ADDENDUM NO. 1

**ARCADIA HIGH SCHOOL
LOCKER ROOM ALTERATION
ARCADIA UNIFIED SCHOOL DISTRICT**

tBP/ARCHITECTURE
4611 Teller Avenue
Newport Beach, CA 92660
949-673-0300

This Addendum forms a part of the Contract Documents and modifies the original Bidding Drawings dated August 15, 2024, and Specifications dated July 2024. Acknowledge receipt of this Addendum in space provided on the Bid Form. Failure to acknowledge may subject Bidder to disqualification.

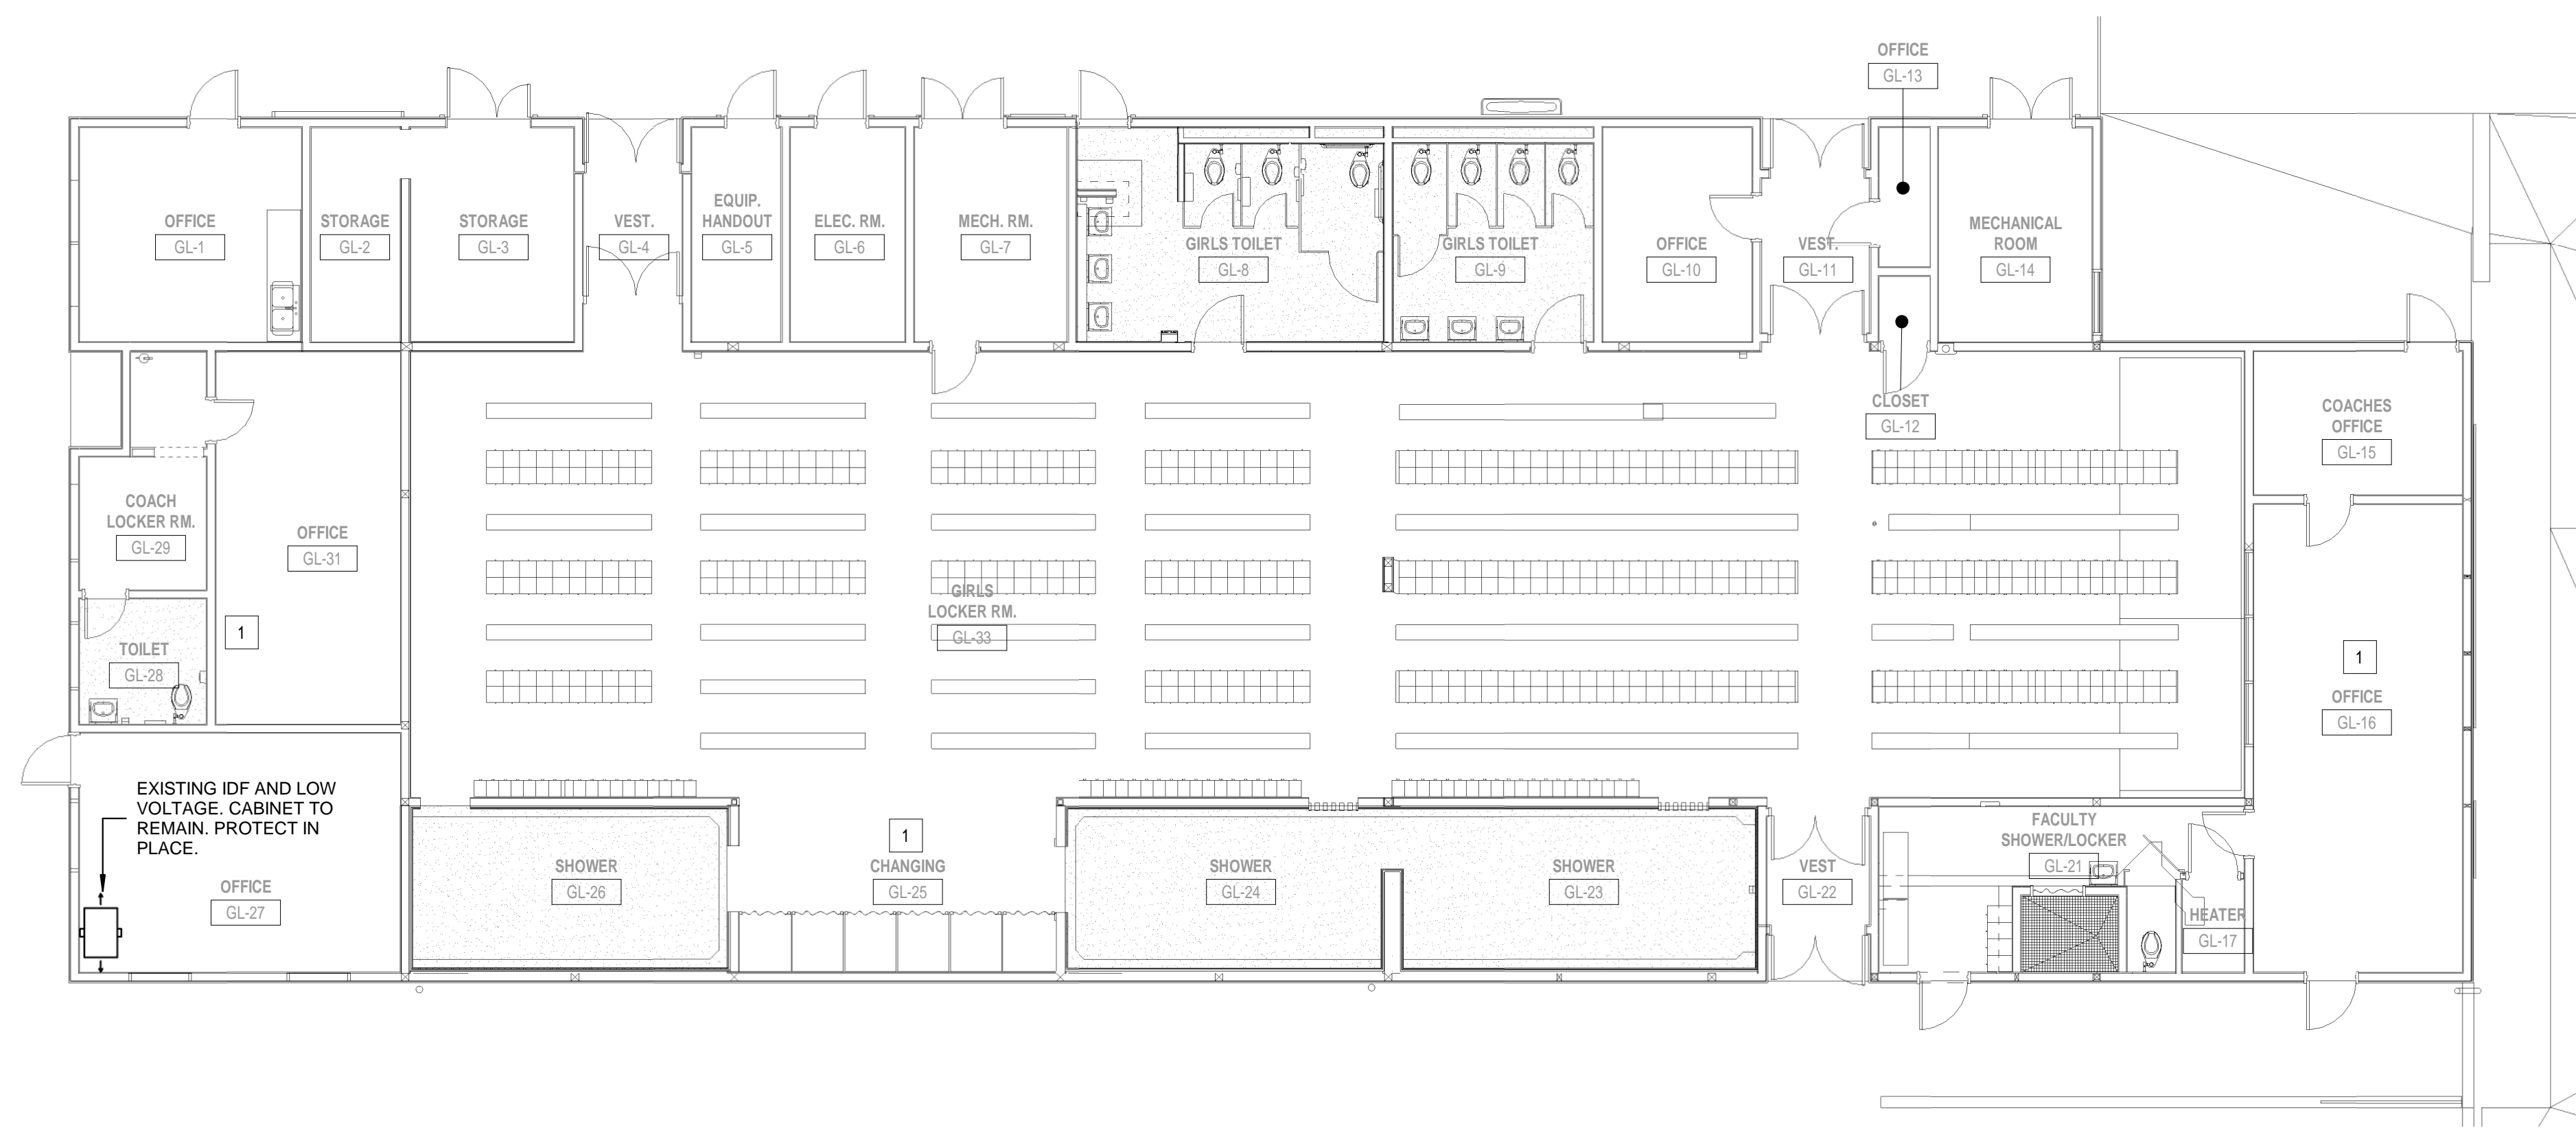
31. SHEET E4.2 – BUILDING GL SIGNAL PLAN
Replace full size sheet drawing **E4.2** in its entirety, issued with this addendum.
Changes include:
 - a. Remove audio/video and data outlet in Locker Room GL-1.

E5.1

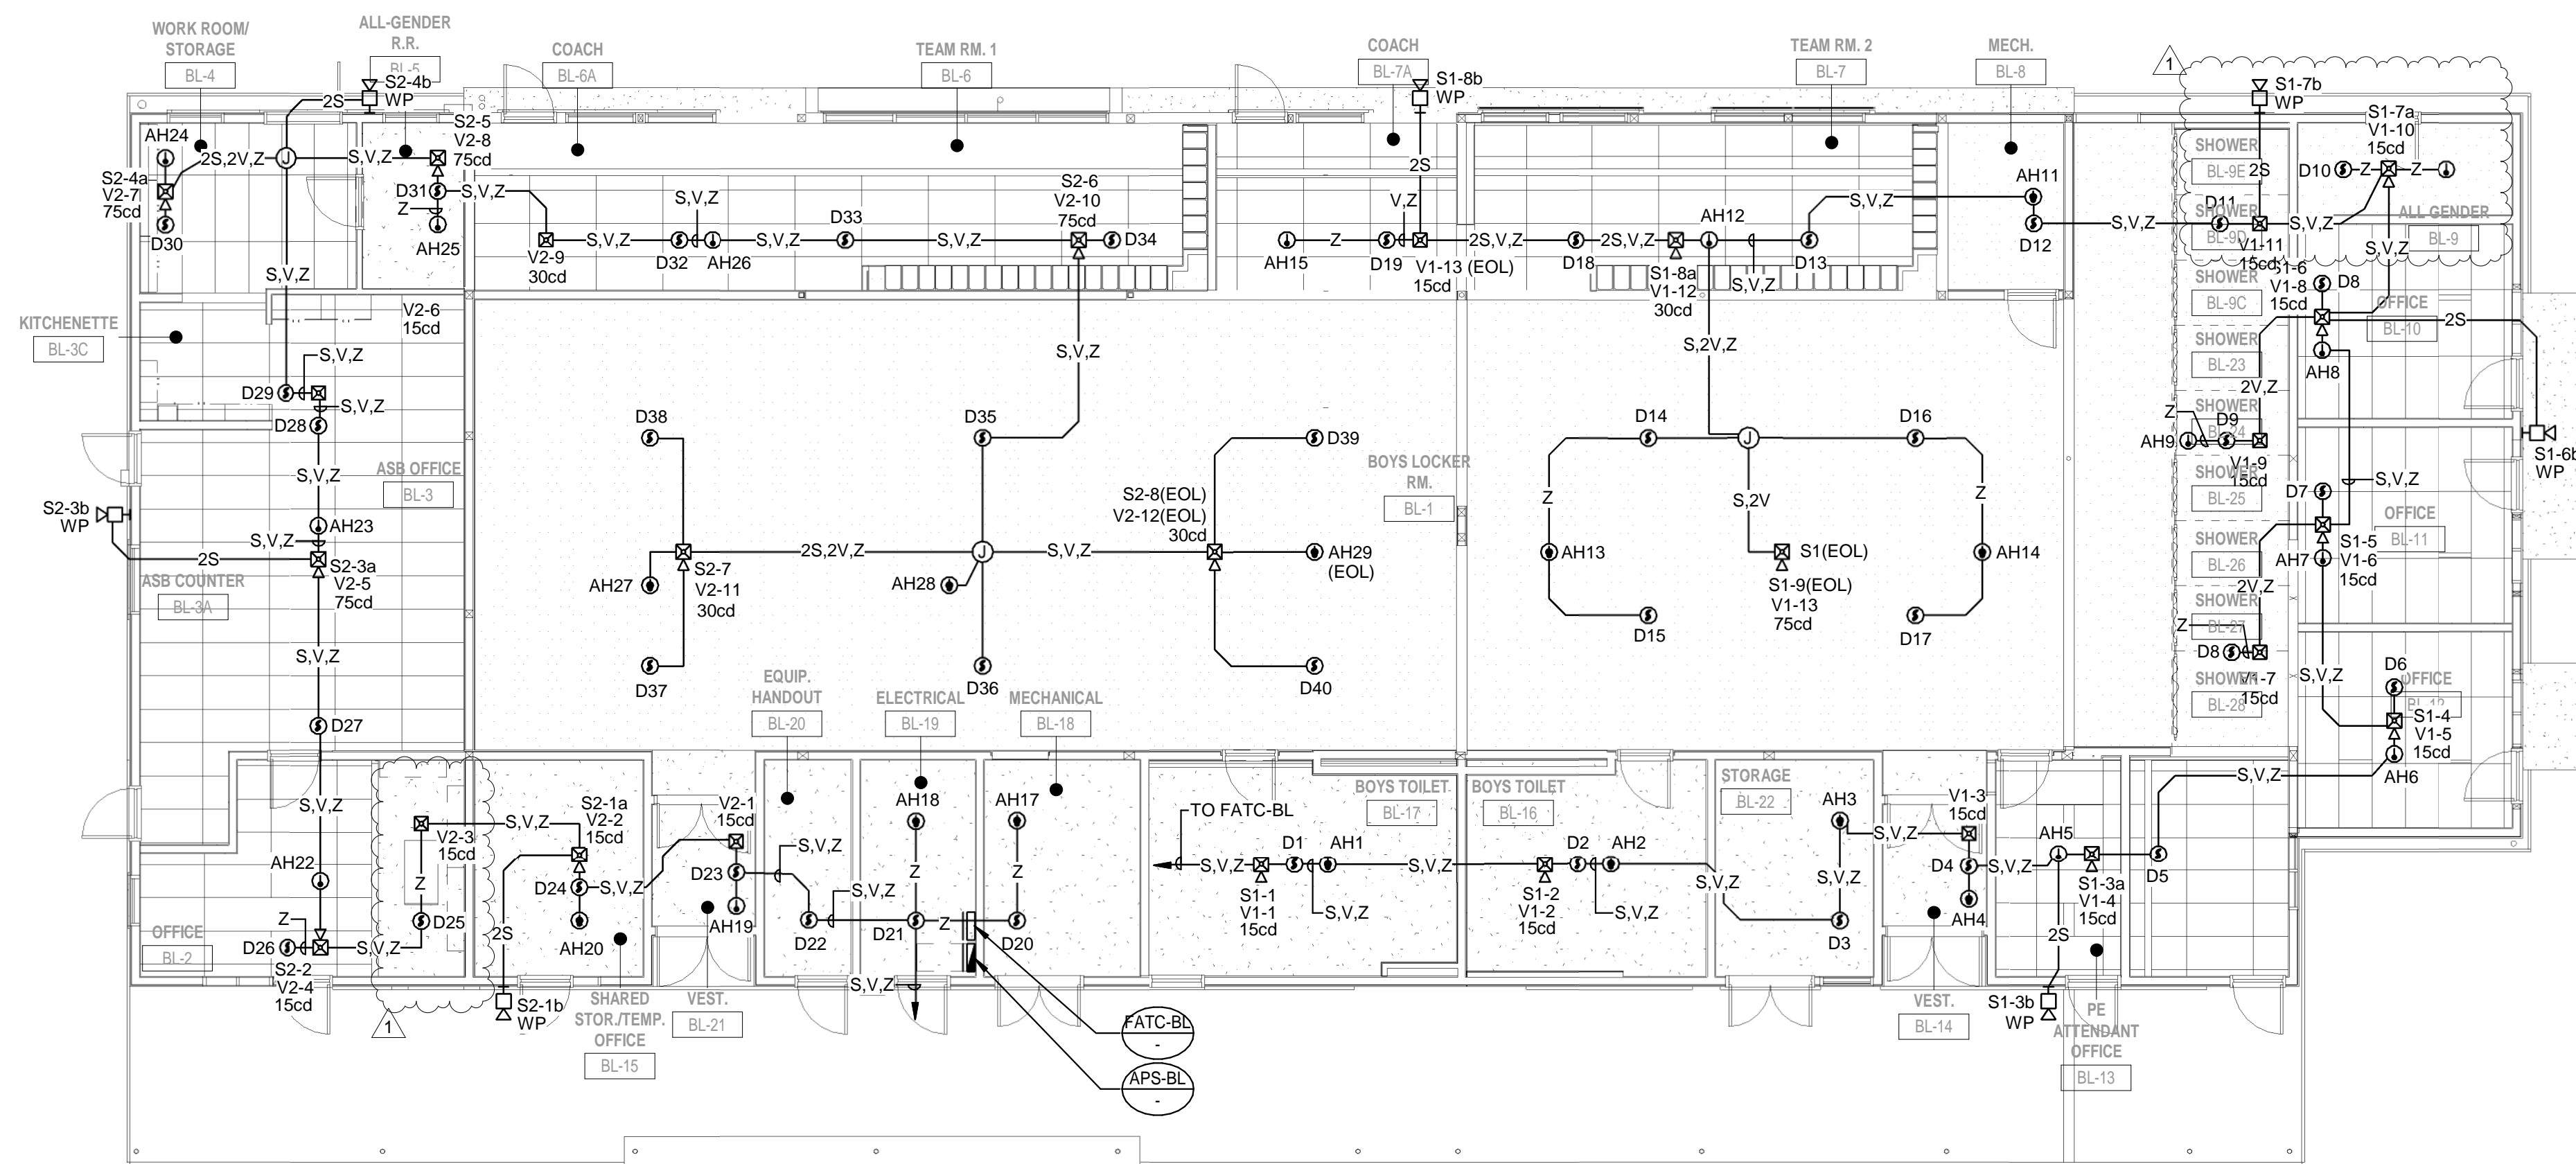
32. SHEET E5.1 – BUILDING BL & GL ROOF ELECTRICAL PLANS
Replace full size sheet drawing **E5.1** in its entirety, issued with this addendum.
Changes include:

- a. Revise electrical connection to EF/BL5 and EF/BL9 in Building BL.
 - b. Revise electrical connection to EF/GL6 and EF/GL10 in Building GL.
33. SHEET E6.1 – BUILDING BL & GL FIRE ALARM PLAN
Replace full size sheet drawing **E6.1** in its entirety, issued with this addendum.
Changes include:
